NORTH AMERICAN TUNGSTEN CORPORATION LTD.

# RESPONSE TO REQUEST FOR SUPPLEMENTARY INFORMATION FOR THE MACTUNG PROJECT PROPOSAL (YESAB 2008-0304)

JULY 15, 2011  
ISSUED FOR USE  
EBA FILE: W23101211.003

Figure 2.3-1: Mean Annual Precipitation versus Elevation for the Regional Climate Stations

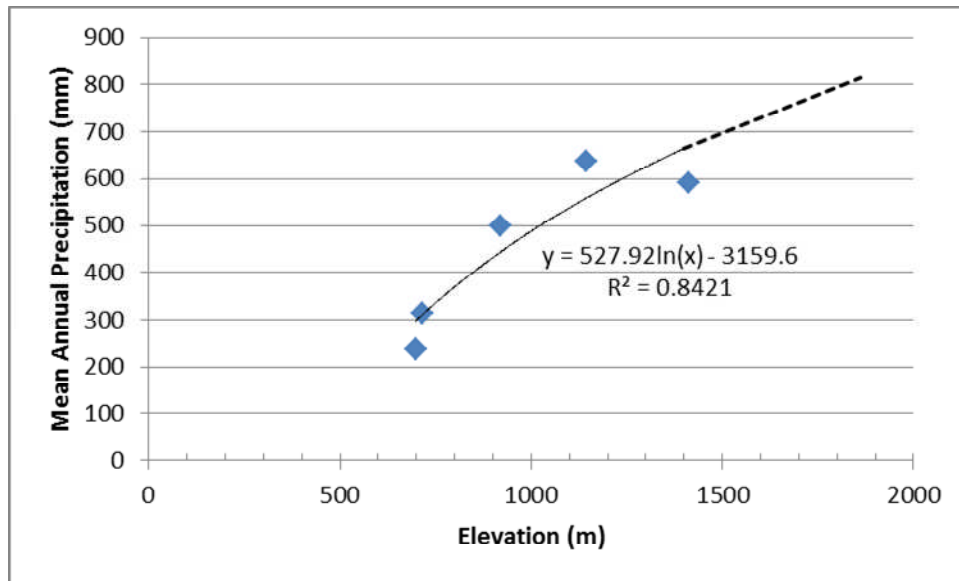
Provide an updated water balance model by incorporating the new hydrological and meteorological data.

The mean annual precipitation (MAP) was plotted against station elevation as shown in Figure 2.3-1. A fair correlation ( $R^2$  equal to 0.84) results from the plot. The regional analysis MAP for the Mactung site is estimated to be 815 mm from extrapolation to the site elevation of 1860 m using the equation shown in Figure 2.3-1.

For the purpose of the revised water balance, the regional precipitation of 815 mm was used as mean annual direct precipitation as it was found to be the most conservative approach. This value is 20% smaller than the previously estimated 1020 mm annual precipitation used in the previous water balances in Section 5.4 of the “Response to YESAB’s Adequacy Review Report” (EBA, July 2009).

**Figure 2.5-1**

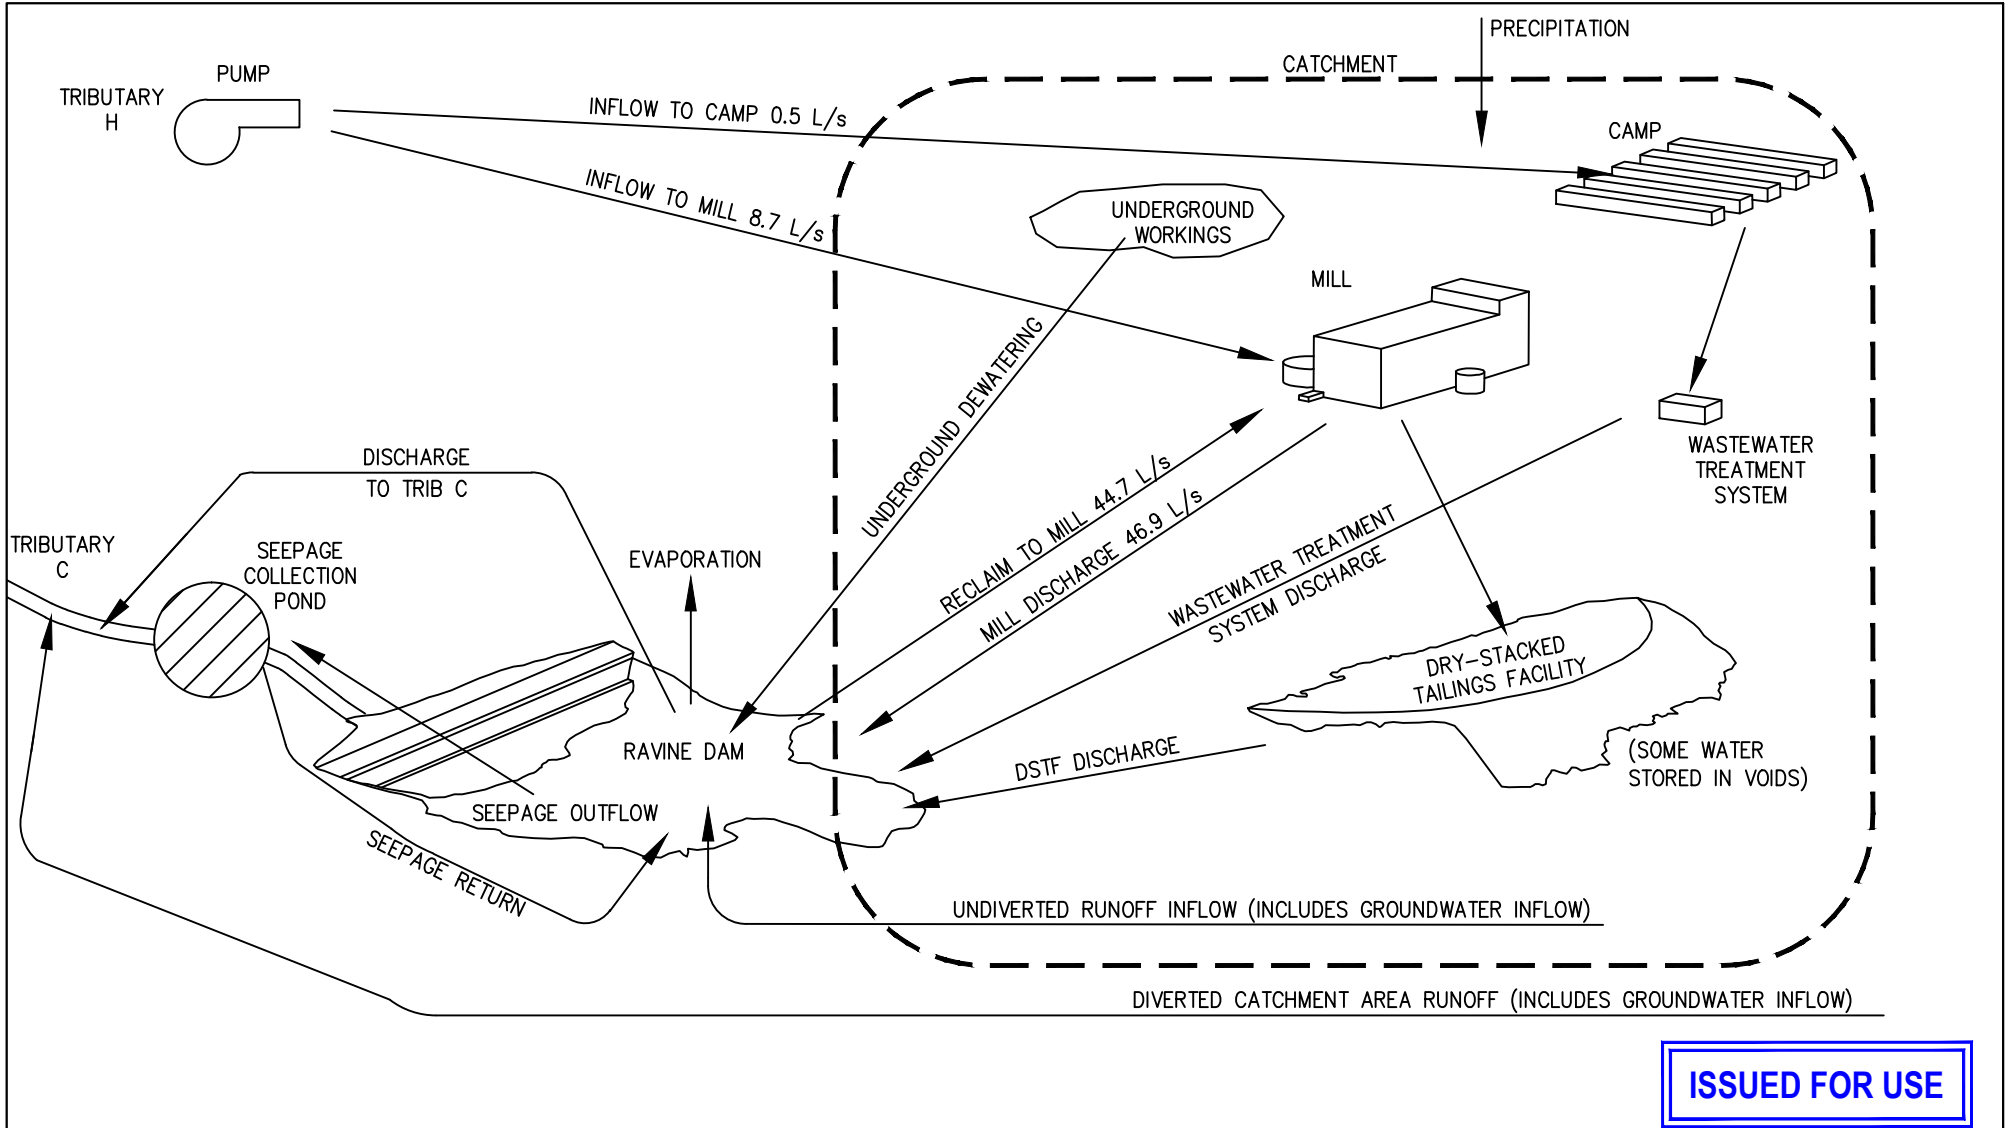
R1. Provide a discussion on if and how the updated water balance model affects the design and operation of the proposed project. The discussion should include but is not limited to:

As mentioned in previous documents submitted to YESAB, the designed operating volume of the reservoir is 540,000 m<sup>3</sup>. The maximum volume of water the reservoir can hold before over-topping the dam is 612,000 m<sup>3</sup>. The maximum volume of water calculated in the water balance tables to be held in the reservoir at any one time during the proposed mine life is approximately 538,000 m<sup>3</sup> (July of year 1, wet year).
